R. R. Sgarro  
Manager, Nuclear Regulatory Affairs

**BELL BEND NUCLEAR POWER PLANT  
RESPONSE TO ENVIRONMENTAL  
REQUESTS FOR ADDITIONAL  
INFORMATION, FOURTH SUBMITTAL  
BNP-2009-266      Docket No. 52-039**

Response Status for Environmental Requests for Additional Information  
Bell Bend Nuclear Power Plant  
Luzerne County Pennsylvania

Responses to Environmental Requests for Additional Information  
Bell Bend Nuclear Power Plant  
Luzerne County Pennsylvania

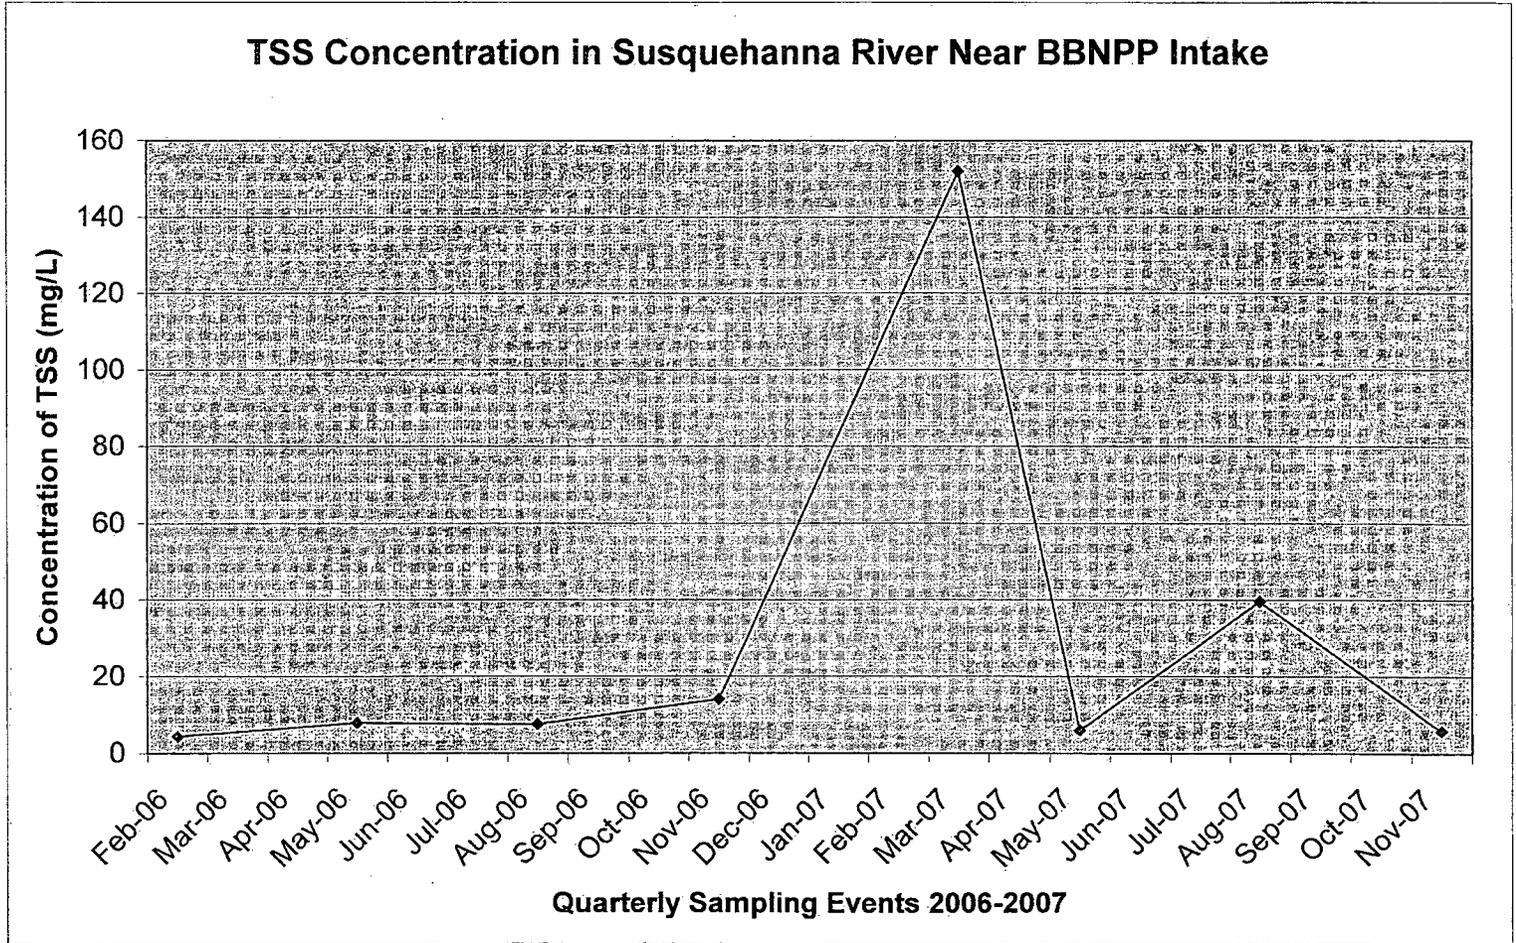
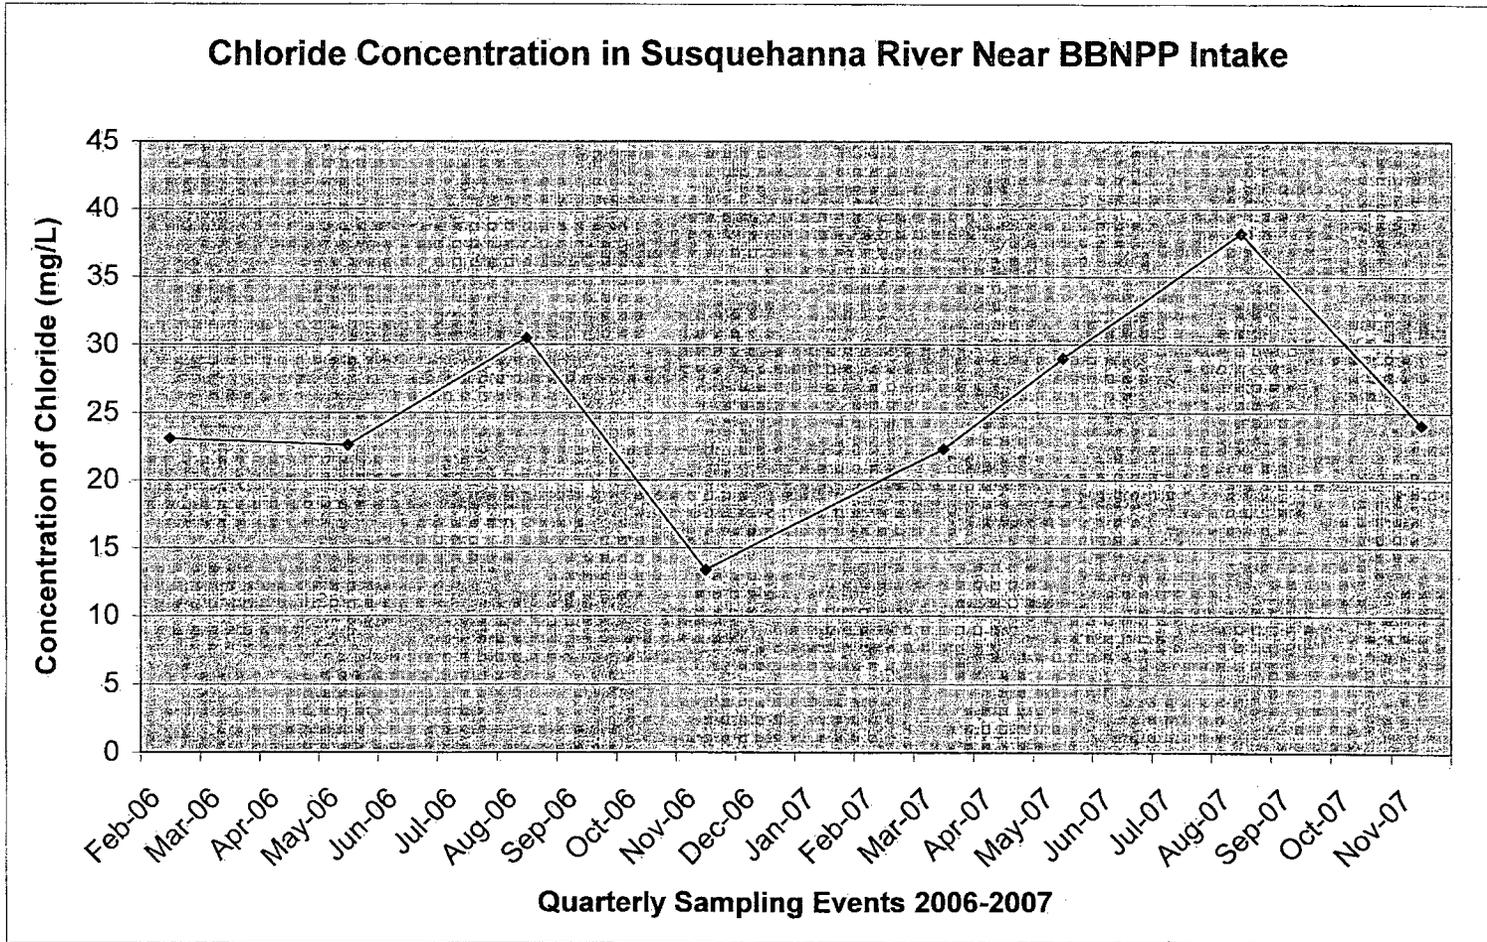
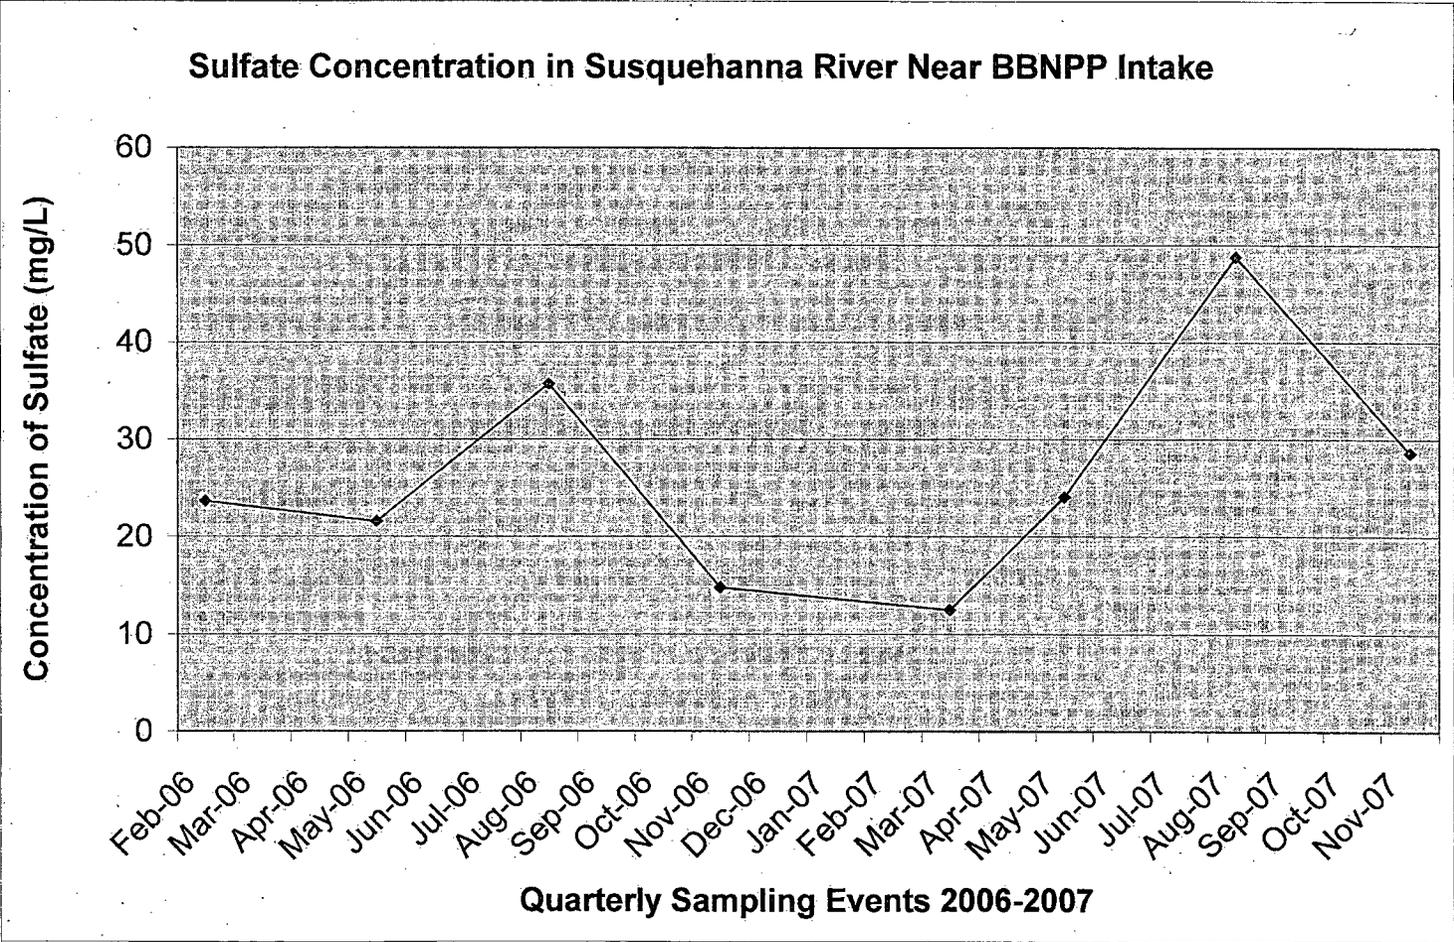
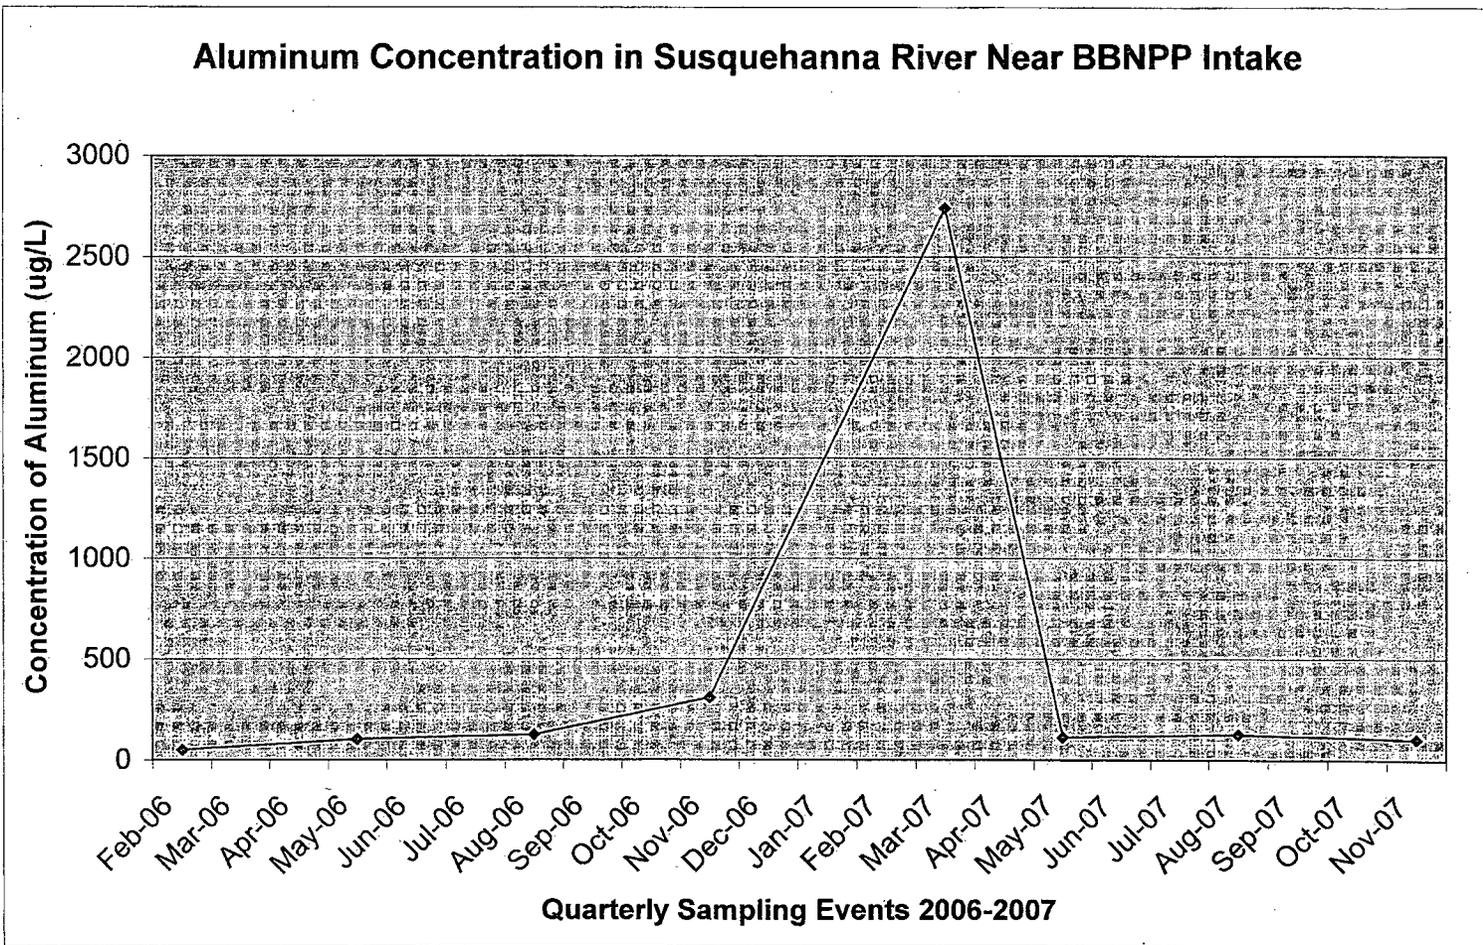
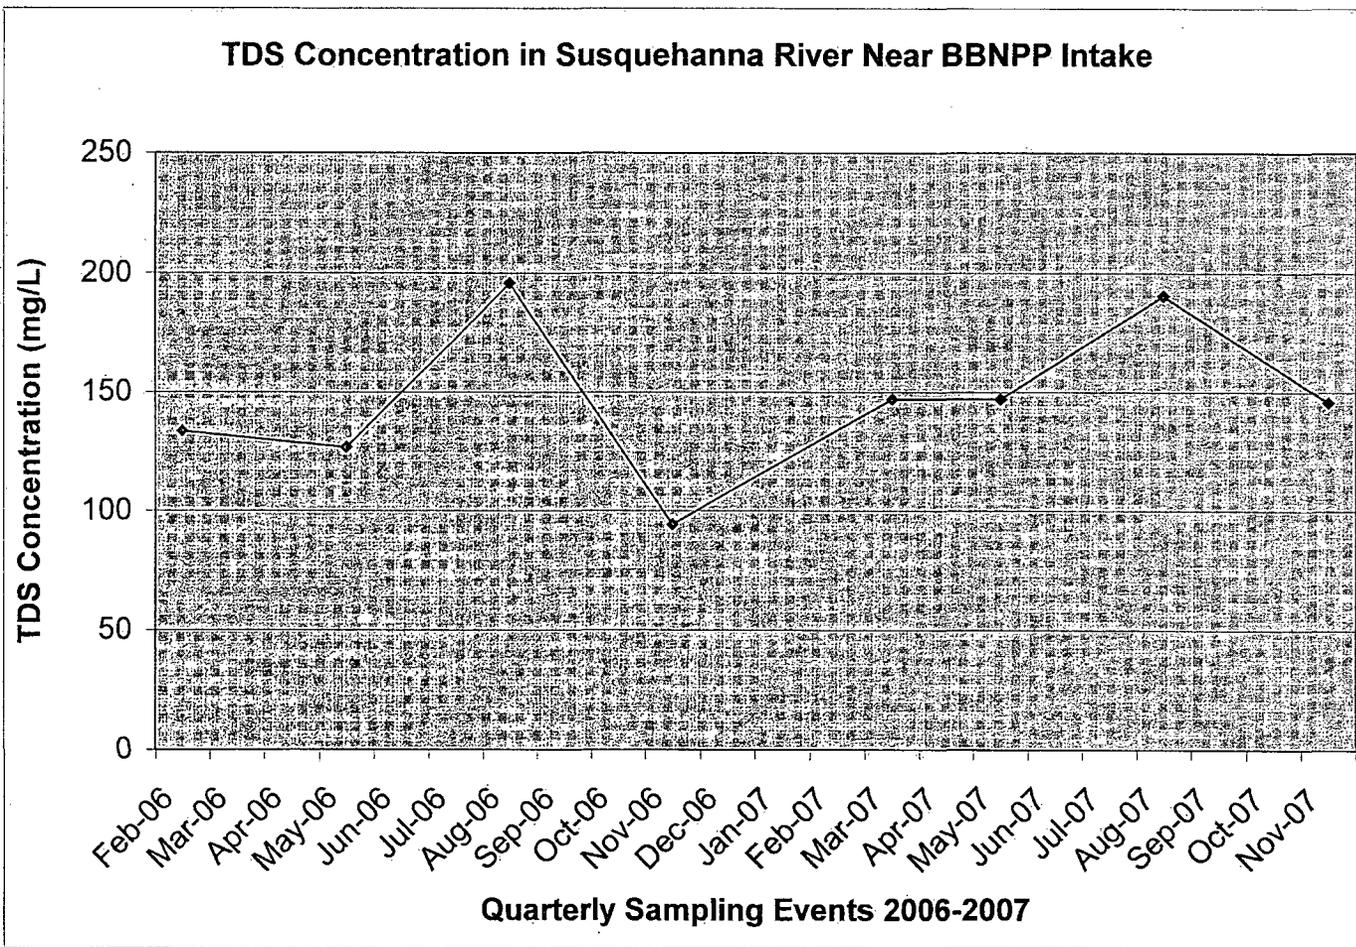
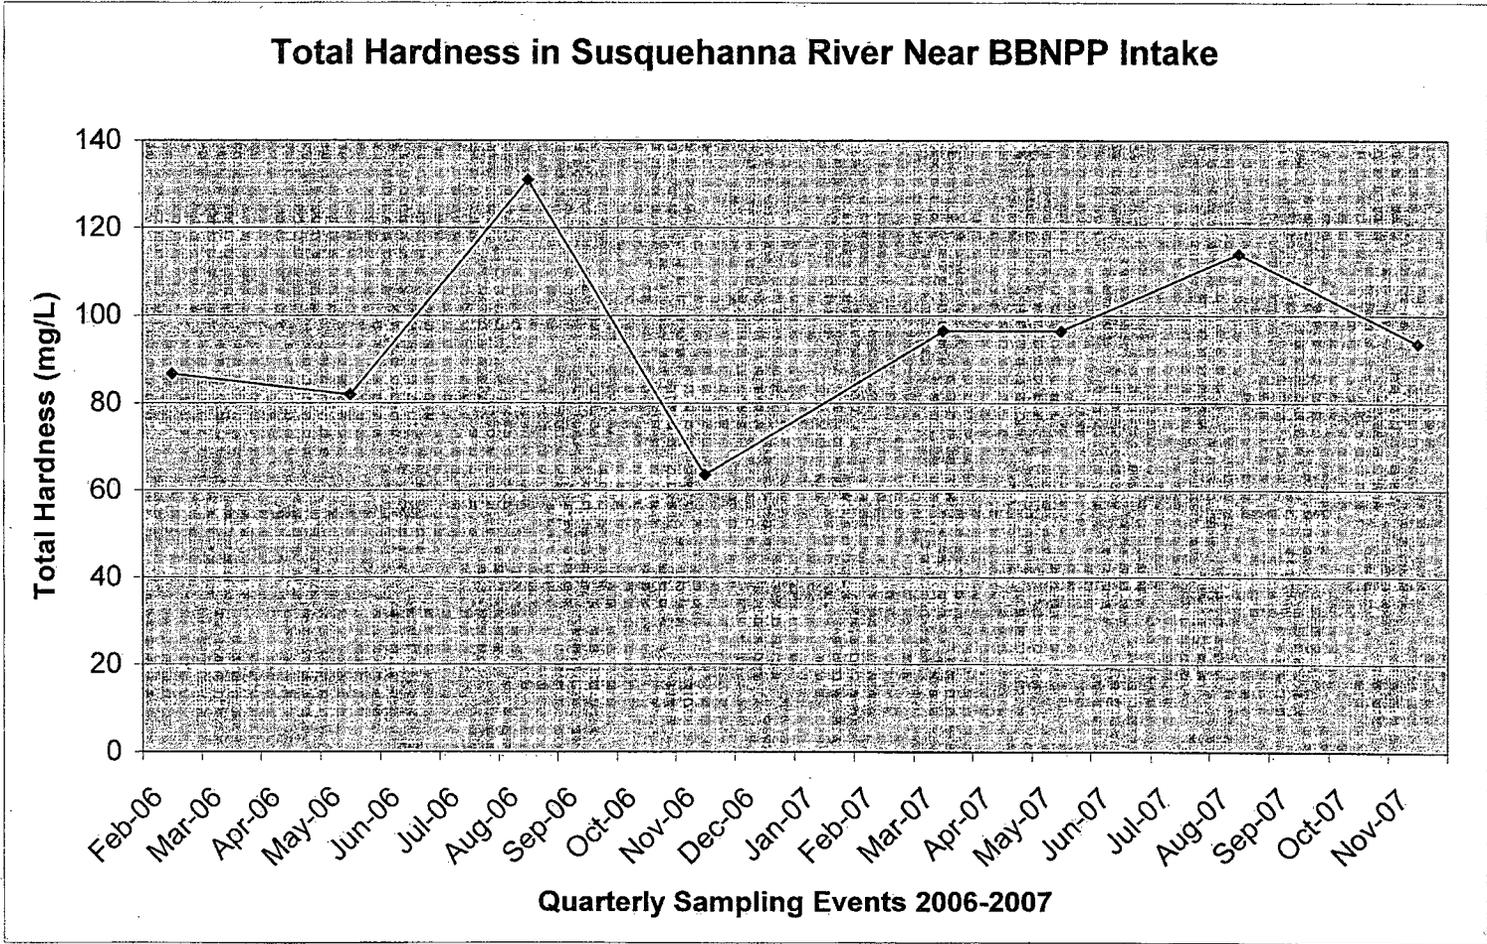
**Summary:** *Provide supplemental information on the intake source water quality data presented in ER Table 3.6-3. Include information on seasonal values of chemical analytes in intake and receiving waters.*

**Response:** Attached is Table 1, Susquehanna River Water Quality at Intake, that presents the results of (approximate) quarterly river sampling that was conducted in 2006 and 2007. Also attached are associated charts of selected, representative river sampling data (from near the intake) that show the results of quarterly monitoring data over time for this two year period. For some "total" metals and suspended solids, the results for this two-year monitoring period are skewed by the results for one sampling event (total aluminum, 3/15/2007) in the first quarter of 2007.
